**SUNDRY NOTICES AND REPORTS ON WELLS**

8. Well Name and No.  
**Burnett Oil 24 Fed Com No. 2**

9. API Well No.  
**30-015-34586**

# EXHIBIT #1

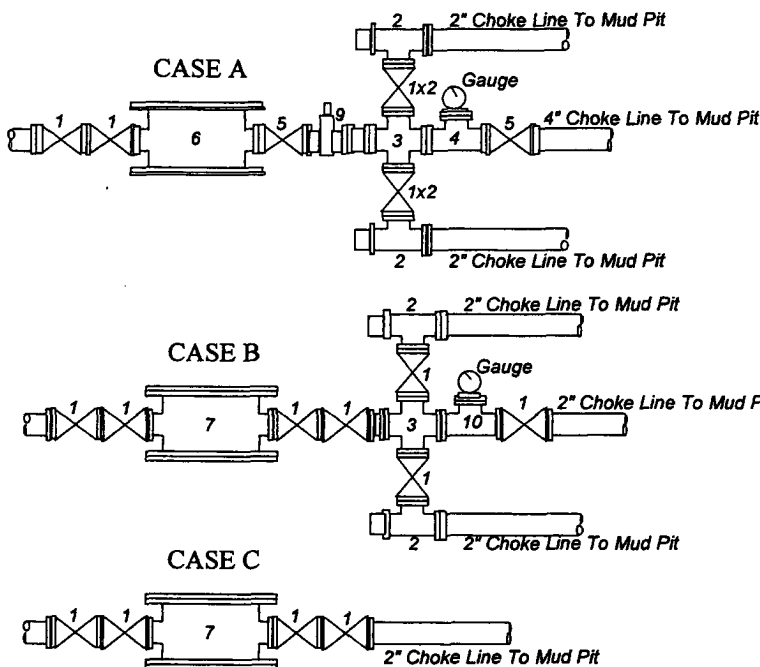
**EOG Resources, Inc. ("EOG"), in the original APD, had submitted Exhibit #1 to indicate the Blowout Preventor with a 11" annular and a working pressure of 5,000 lbs. By this Sundry Notice, EOG desires to amend Exhibit #1 to indicate a Blowout Preventer with a 13.625" annular with the same working pressure of 5000 lbs. Please see revised attached Exhibit #1 attached herewith.**

BOP SIZE	BOP CASE	WORKING PRESSURE	CHOKE CASE
13-5/8"	IV	5000	A
